RE: PART VIII – Housing at 6-9 Upper Patrick Street, Kilkenny City
Planning & Development Acts as amended
Planning & Development Regulations as amended

REPORT – Dated 15th October, 2024

**Refurbishment, Conservation and Extension
Works to 6-9 Upper Patrick Street, Kilkenny for
their conversion to 4 no. studio apartments and 1
no. 2 bedroom house.**

**Chontae Chill Chainnigh
Kilkenny County Council
Planning Report**

Fig2. Proposed Contiguous elevation

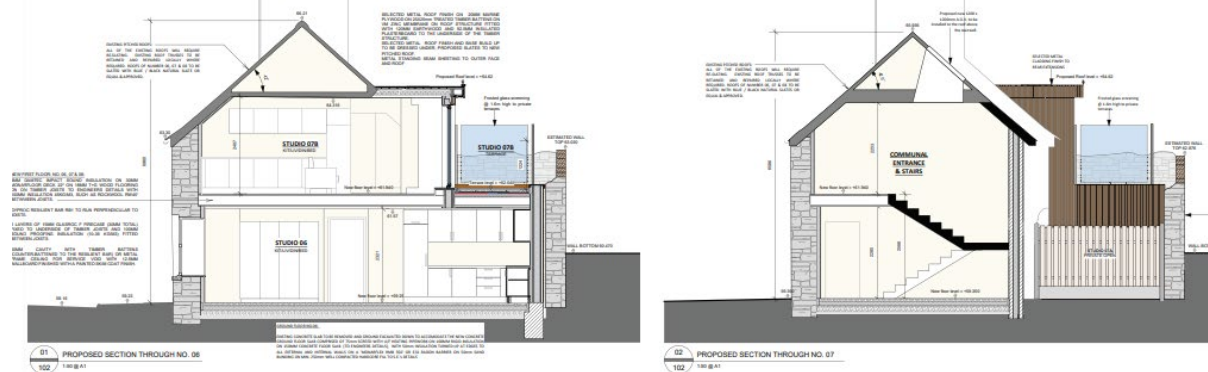
The slate from No. 9 Hairlab is to be retained and reused as per drawing, this is welcome. Natural black blue slate for No. 6 – 8 are welcome as it will replace a non-original fibre cement slate. New lime render be inserted on the buildings, this will replace the current cementitious render.

DRAWING TITLE:
PROPOSED ELEVATIONS

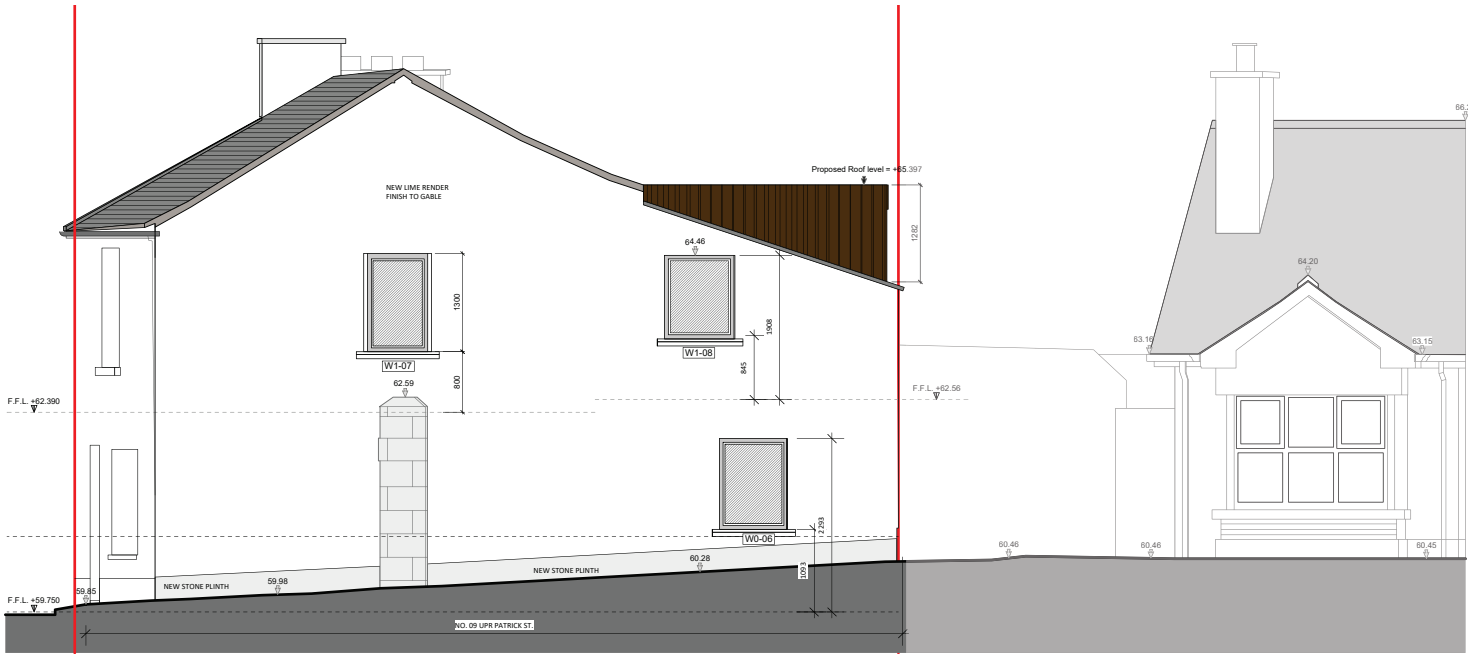
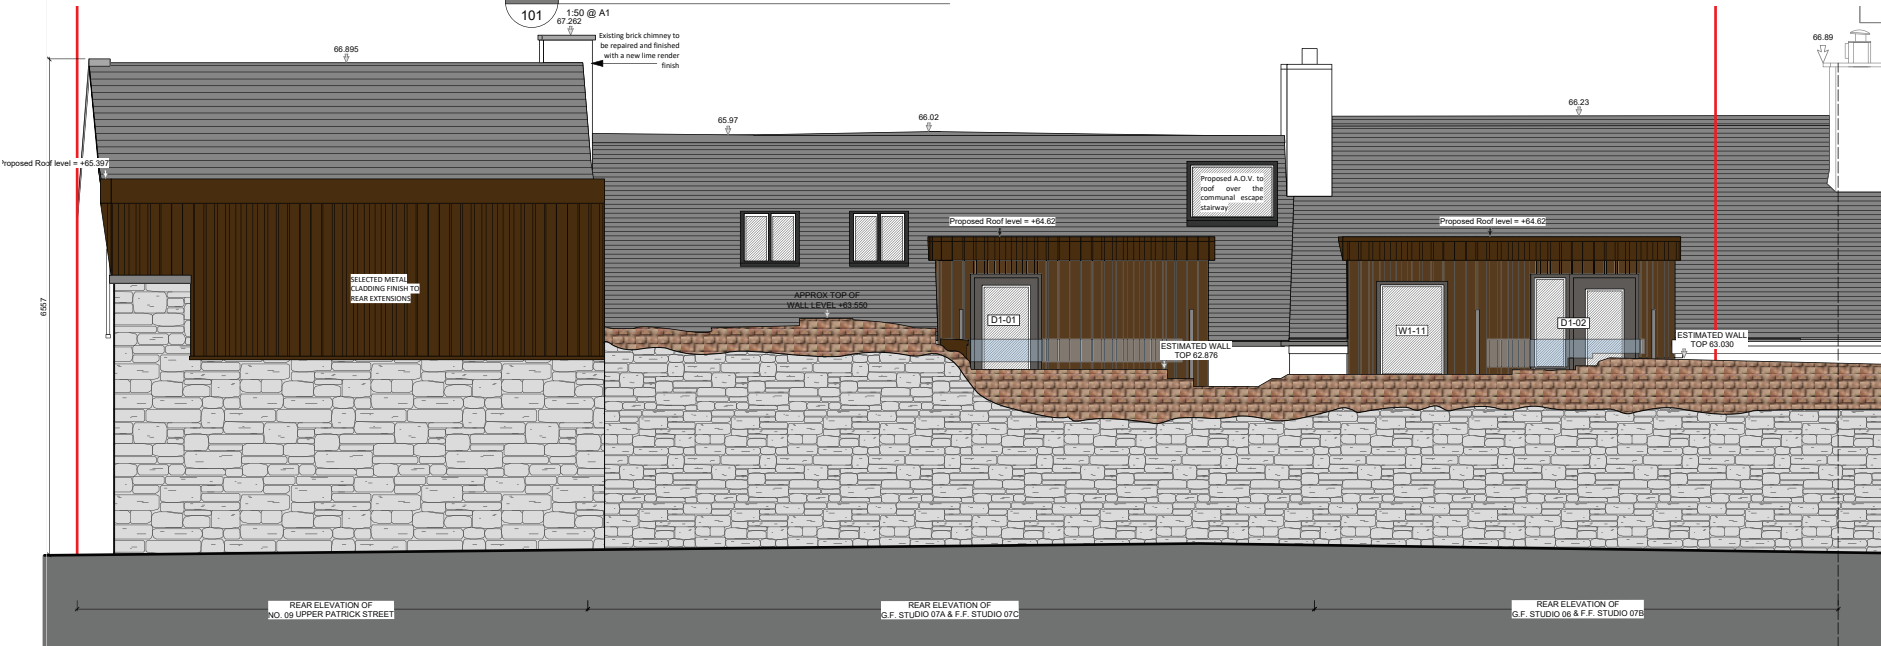
Issue	KCC Housing Section Response
1a	Wall or Frosted Glass to the balconies to the rear.	We will provide frosted/translucent glass to the first-floor balconies to protect the privacy of the residents of the Old School Yard.
1b	Garden and tree to the School Yard	Access to the rear stone wall will be required during construction to determine if repairs are required. We will reinstate a small, planted area in consultation with the tenants of the Old School Yard.
1c	Construction traffic	A Preliminary Health and Safety plan will be issued at tender stage to potential contractors outlining the site constraints which will have to be adhered to and taken into account in developing the site-specific Health and Safety plan. Site constraints will include a requirement to maintain access for existing residents to their homes, site security and a restriction on working hours.
1d	Construction Parking

- **Requests Wall or Frosted Glass to the balconies to the rear.**
- **Protection of Garden and tree to the School Yard**
- **Construction traffic**
- **Construction Parking**
- **Parking by new tenants**
- **Current Parking by others in the School Yard**
- **Project Duration**
- **Common Roof on no. 5 & 6 – concern over new joint between fibre cement slates and new natural slates.**
- **Concern regarding the joint between the new lime render and cement render.**
- **Condition of boundary wall to yard between no. 5 & 6**

A. Frosted glass to the rear of the balconies as well as the sides.
